SAFETY EVALUATION REPORT  
FOR THE  
FORT ST. VRAIN PLANT  
ACCIDENT REANALYSES  
IN SUPPORT OF  
100% POWER OPERATION

The evaluation which follows addresses the accident reanalyses (Nov. 1977 submittal) in support of full power operation.

FIGURE 2.1  
 POWER-TO-FLOW RATIO TECHNICAL SPECIFICATION  
 CURVE FOR FORT ST. VRAIN

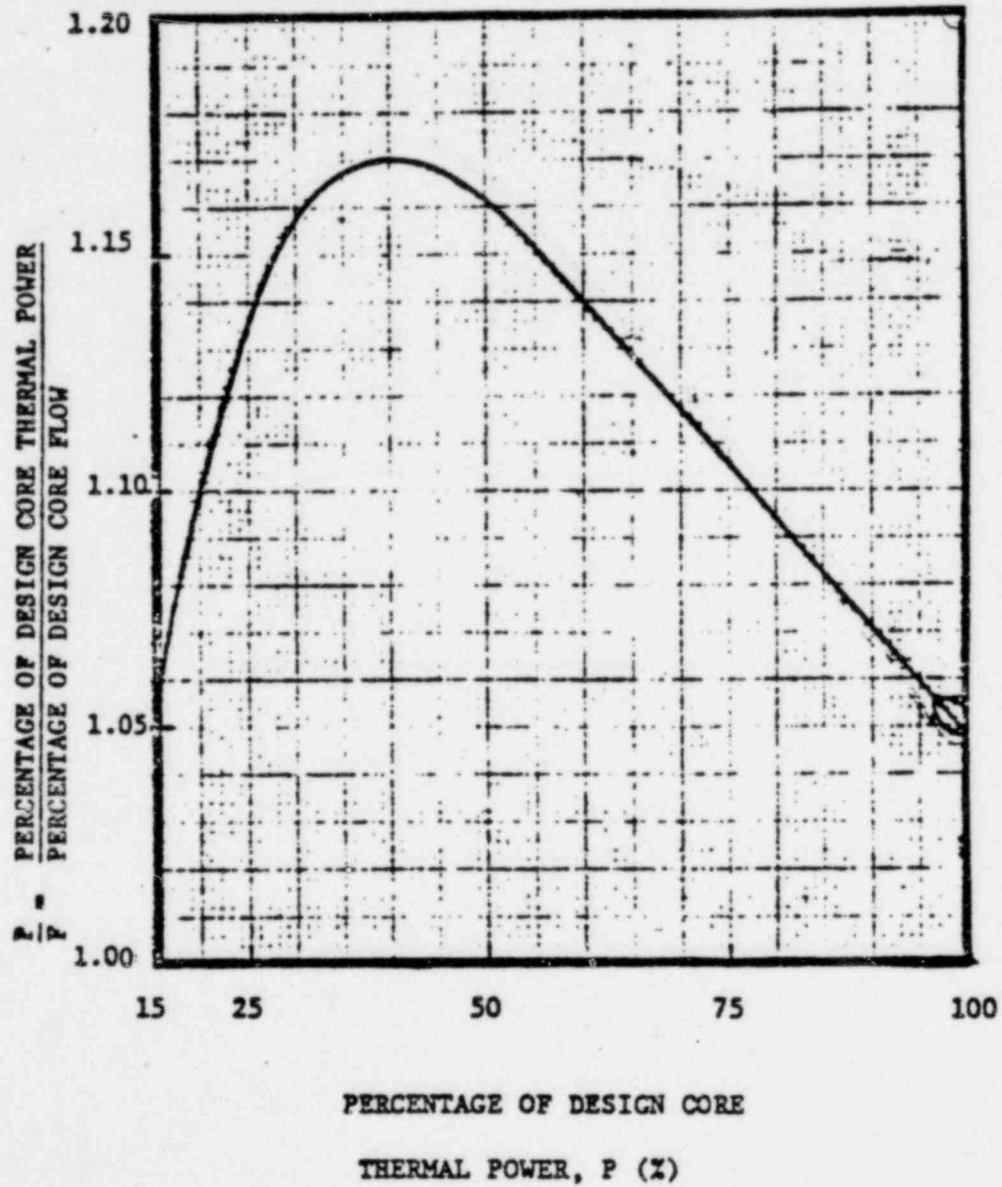
In our review of initial conditions with respect to the allowable power-to-flow ratios in the technical specifications, it was noted that for limited periods of time, the technical specifications allow full power operation at power-to-flow ratios greater than 1.05 based on steady state time-at-temperature limits for fuel damage. The licensee considers operation in this region to be a degraded plant condition and has stated that normal practice is not to operate with power-to-flow ratios greater than 1.05. Since operation in this degraded mode has not been considered in the accident reanalyses, deliberate operation at power-to-flow ratios in excess of the curve shown as Figure 2.1 (Figure 3.1-1 of the technical specifications) is not acceptable to the staff. If the power-to-flow ratio limits of Figure 2.1 are exceeded, we will require that the operator act promptly to bring the plant within

allowable limits. We will require the licensee to propose technical specification revisions to conform to this position prior to approval of 100 percent power operation.

FIGURE 3.1

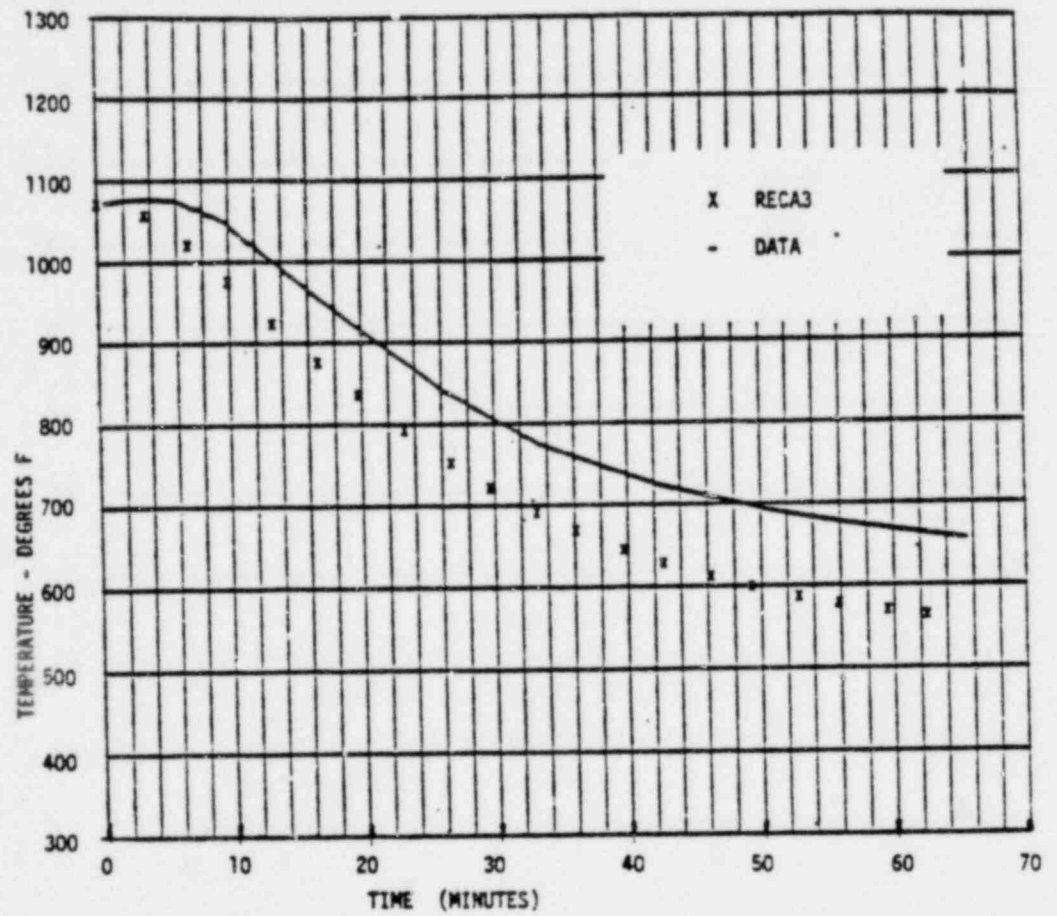
The RECA3 comparisons to available scram data indicate that predictions of helium temperature in the maximum peaking factor refueling regions are in good agreement with the measured temperatures. However, the code underpredicted helium temperatures in the north-west quadrant of the core by as much as 50°F to 100°F in the 40-70 second time frame as shown in Figure 3.1. This discrepancy may be due to excess bypass flow through fuel region gaps in this

quadrant. Such observations are consistent with region outlet temperature fluctuation phenomena observed during plant operation. The fluctuations were most prominent in this region, and are believed to be due to the opening and closing of axial gaps between fuel blocks.

The discrepancy between the predicted and measured region outlet temperatures is of concern to the staff. We will therefore require that the applicant perform at least one verification transient subsequent to corrective action taken to eliminate the core fluctuations. This transient can be a reactor trip from power, and the verification should consist of comparisons of measured to predicted region outlet temperatures. Acceptable\* predictions of the measured data, including resolution of the previously observed northwest quadrant discrepancies, will be required before full power operation is allowed. Alternatively, the licensee should identify an acceptable operating power level, based on accident analyses in which this uncertainty has been properly accounted for.

FIGURE 3.2

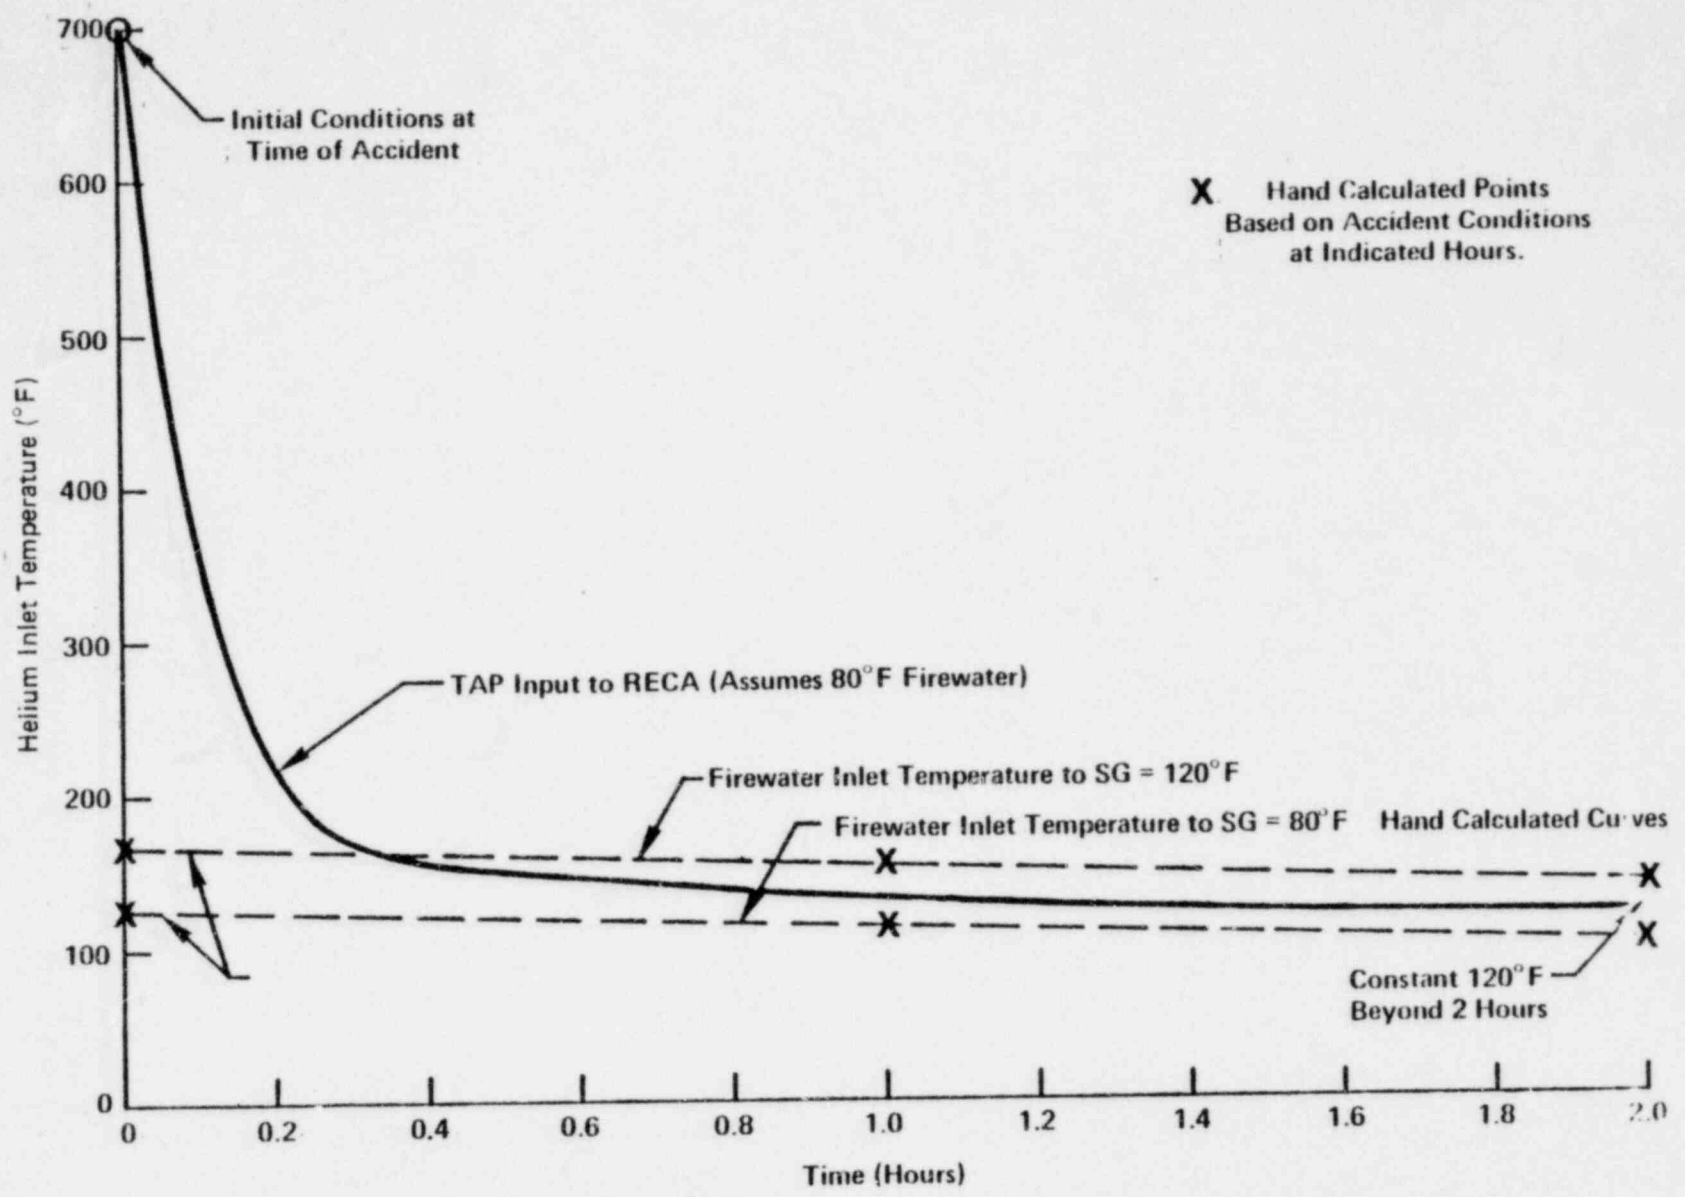
The TAP code is used to calculate the temperature of the helium exiting the steam generators and entering the upper plenum and core as input to the RECA3 calculations. Although the TAP code has not been verified against data, hand calculations were performed by the licensee to confirm the calculational accuracy of the TAP code. These comparisons are provided in Figure 3.2 and show the TAP calculations to be in good agreement with the hand-calculated values of helium inlet temperature.

Moreover, the applicant stated that because of the excellent heat transfer capability of the steam generators at decay heat levels coupled with the low core flow assumed subsequent to accident initiation, the helium temperature at

the exit to the steam generators will be approximately the same as the feedwater temperature, and therefore should not be a highly sensitive parameter. Based on the above considerations and the confirmatory hand calculations, the staff finds the use of the TAP code acceptable for the purpose of calculating the helium temperature exiting the steam generator.
